Access Compliance Report Public Rights-of-Way (Curb Ramps)

Main Street: N/A		Cross Street: REATA_RD		Location:	NW
ADA ID: RPRK211118135428	Ramp Type: Type 1 - Perpendicular	Initial Pass/Fail: Fail	Overall Compliance: No	Severity Score:	16

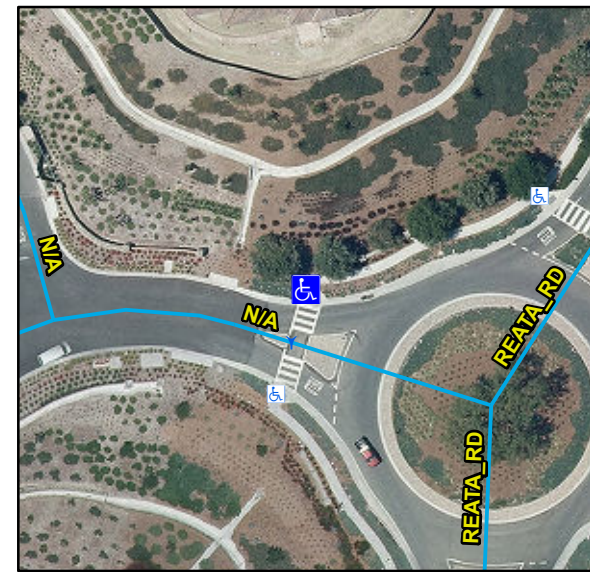
Possible Solutions:

Remove & Replace Entire Ramp.

Compliance	Description	Data	Compliance	Description	Data
N/A	Ramp Length (in)	65	N/A	Flare Type LT	
Yes	Ramp Width (in)	60			N/A
No	Ramp Run Slope (%)	10.1	N/A	Flare Slope LT (%)	N/A
Yes	Ramp Cross Slope (%)	1.3	N/A	Flare Traversable LT	N/A
N/A	Landing Present	N/A	N/A	Flare Type RT	
N/A	Landing Length (in)	N/A			N/A
N/A	Landing Width (in)	N/A	N/A	Flare Slope RT (%)	N/A
N/A	Landing Run Slope (%)	N/A	N/A	Flare Traversable RT	N/A
N/A	Landing Cross Slope (%)	N/A	N/A	DWS Provided	N/A
N/A	Landing Movement Obstructed?	N/A	N/A	DWS Contrast	N/A
	Landing Movement Type	N/A	N/A	DWS Length (in)	N/A
N/A	Landing Shared	N/A	N/A	DWS Full Width	N/A
N/A	Clear Space	N/A	N/A	DWS Offset Left (in)	N/A
N/A	Clear Space To Crosswalk (in)	N/A	N/A	DWS Offset Right (in)	N/A
N/A	Marked Crosswalk 1	Yes	N/A	Marked Crosswalk 2	N/A
	Crossing 1 Direction	SW		Crossing 2 Direction	N/A
	Marked Crosswalk 1 Width (in)	144		Marked Crosswalk 2 Width (in)	N/A

R304.2.2, STD 1115
